Global Cleantech Innovation Programme (GCIP) to accelerate the uptake and investments in innovative cleantech solutions

GEF Secretariat Review for Program Framework Document (PFD) entry – GEF - 7

10408

UNIDO

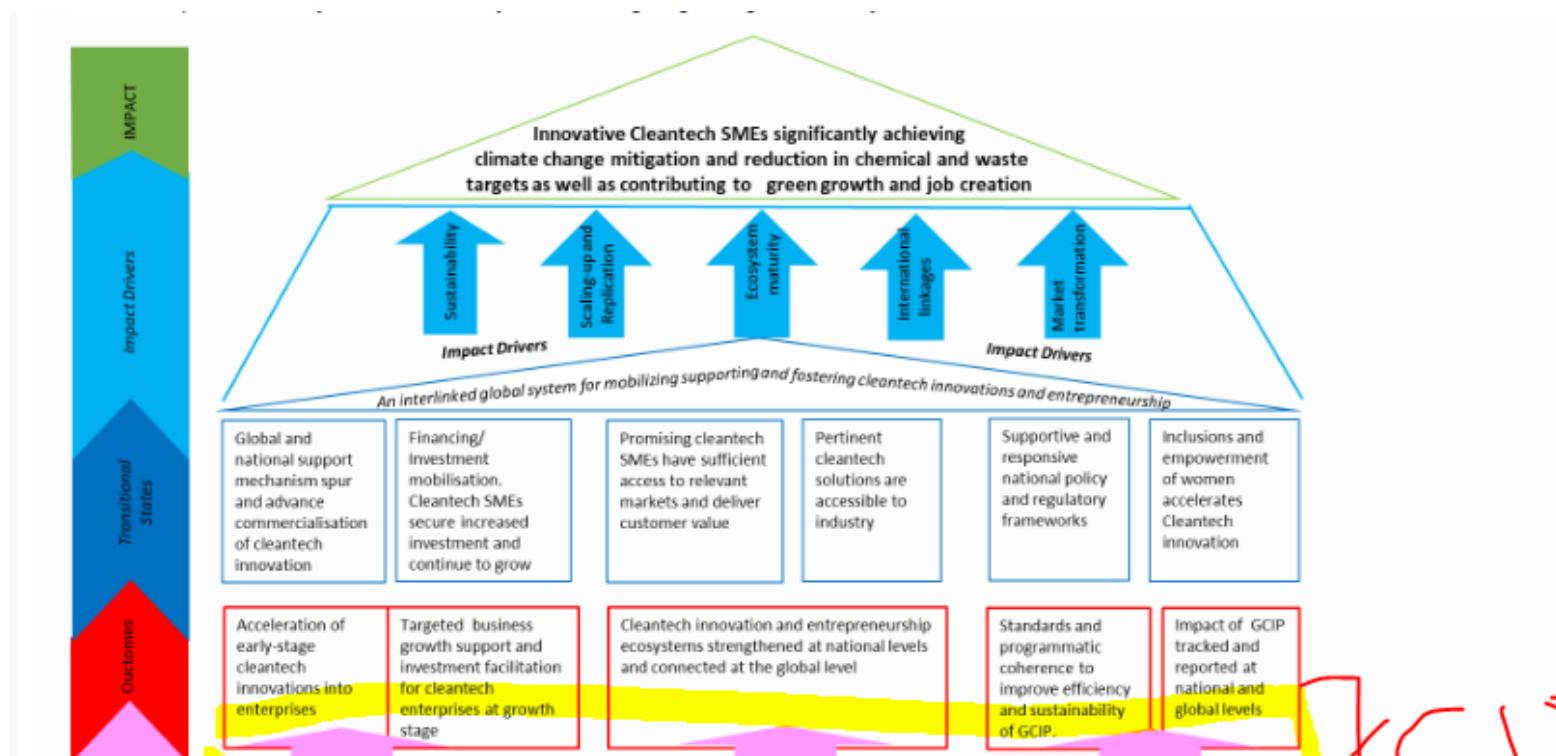
2. On Pillar 1: See and address comments relevant to the classification between INV and TA outcomes, as stated in Part 1 Box 2. OK

3. Please note there is no heading for Pillar 3 and Outcome 3.1. Please revise. OK
